## BMW Motorrad USA

### Service Information Bulletin

#### **\*\*Notice of Recall 10V-273\*\***

**Subject:** Replacement of the Top Take-Up Roller Bracket for the Drive Chain and if applicable, the Spring Strut Spray (mud) guard.

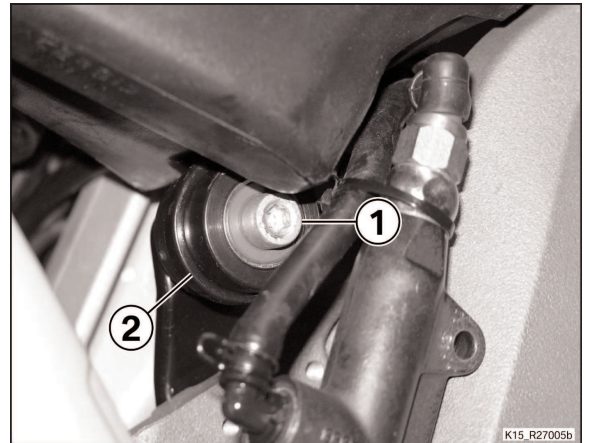
**Do not** replace the Air Damping System if the rubber boot shows only slight signs of chafing.

**3: Removing original bracket for top chain take-up roller:**

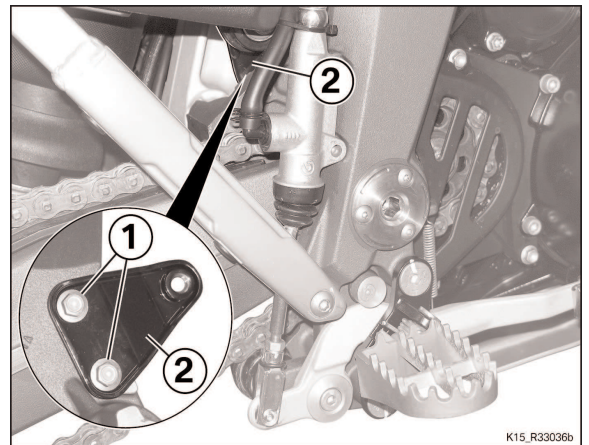
Remove screws (1) and remove holder (2).

**4: Installing replacement bracket for top chain take-up roller:**

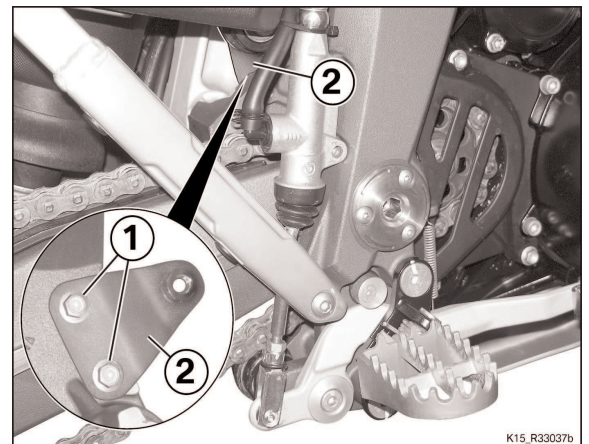
Secure bracket (2) with screws (1).

**8:** Checking/replacing mudguard for spring strut (only G 650 Xchallenge (0165/0195)):

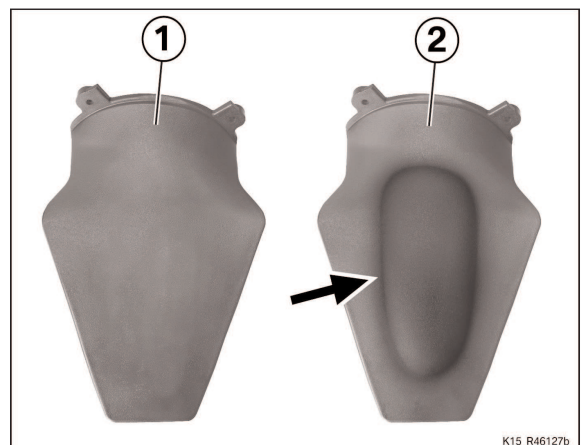
Remove mud guard (1) without curvature and replace it with mudguard (2) with curvature (arrow) (install only mud guard (2)).
